Project	<b>IEEE 802.16 Broadband Wireless Access Working Group</b> < <a href="http://ieee802.org/16">http://ieee802.org/16</a> >	
Title	<b>Action items from Session #43 and new introductory material for the Working Draft (802.16h-06/015)</b>	
Date Submitted	<b>2006-07-19</b>	
Source(s)	Paul Piggin NextWave Broadband Inc. 12670 High Bluff Drive San Diego CA 92130	Voice: 858 480 3100 Fax: 858 480 3105 <a href="mailto:ppiggin@nextwave.com">ppiggin [at] nextwave.com</a>
Re:	Recirculation of Working Group Review of Working Document 80216h-06 015	
Abstract	This document contains 1) Suggested remedies to action items from session #43 from Working Group Review 2) New material pertaining to the introductory sections of the Working Draft.	
Purpose		
Notice	This document has been prepared to assist IEEE 802.16. It is offered as a basis for discussion and is not binding on the contributing individual(s) or organization(s). The material in this document is subject to change in form and content after further study. The contributor(s) reserve(s) the right to add, amend or withdraw material contained herein.

## Action items from Session #43 and new introductory material for the Working Draft (802

Figure 1 Flowchart algorithm for specific spectrum users.

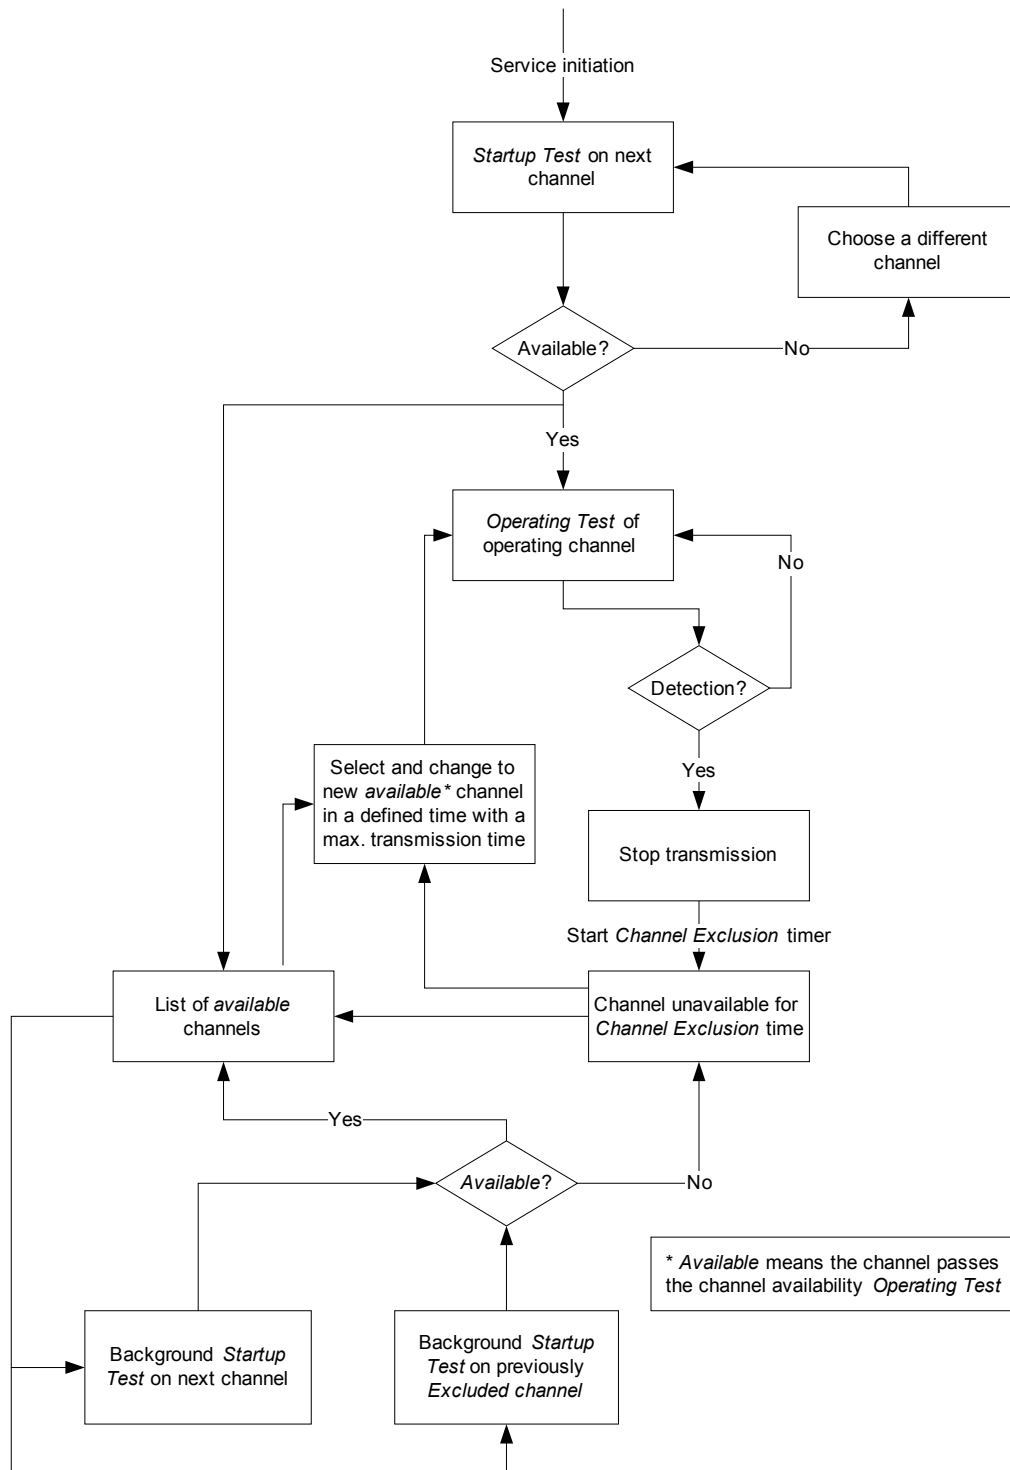
Figure 1 provides the replacement figure for the flowchart algorithm for specific spectrum users. This is Figure h1 in section 6.3.15 of [1].

**Figure 2** Representation of extended channel numbering structure.

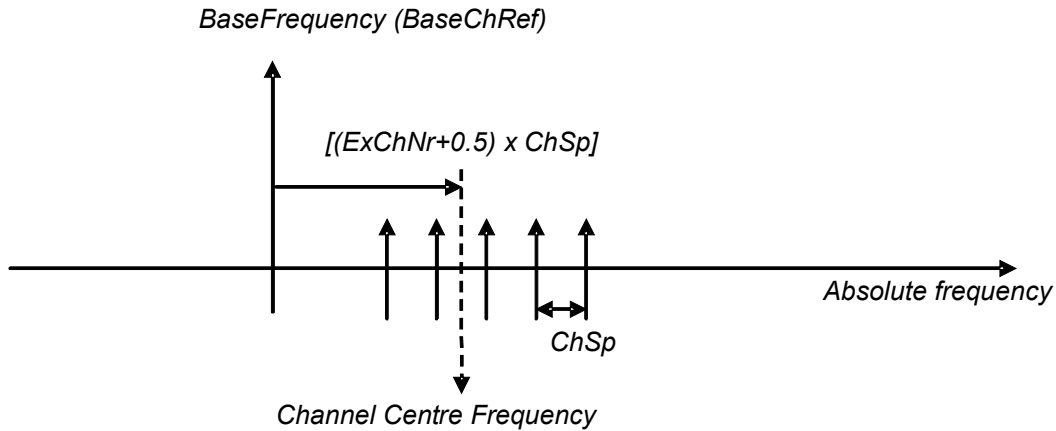
Figure 2 provides a replacement figure for the extended channel numbering structure. This is figure h2 in section 6.4.1.2 of [1].

**Figure xyz** Link level representation of DCS operation: (a) interference and remedial action at the BS, (b) interference and remedial action at the MS/SS.

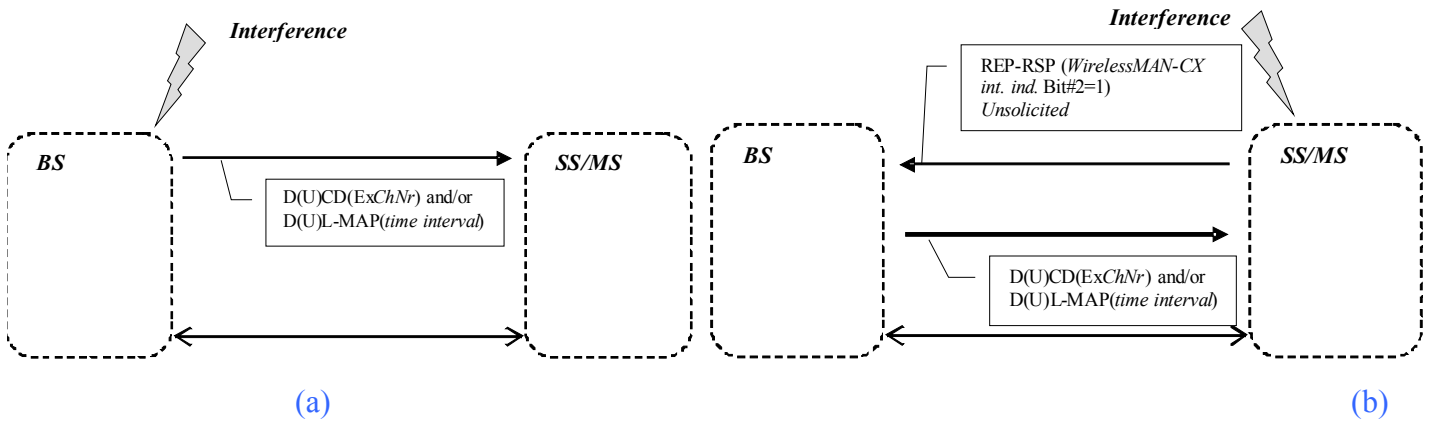
A general example of a DCS solution is provided in figure xyz in which interference detection provides agility in frequency and time to reduce the affects of the incident interference. Figure h1 (section 6.3.15.1), although for specific spectrum users, provides a further example of how DCS can be used to provide resource
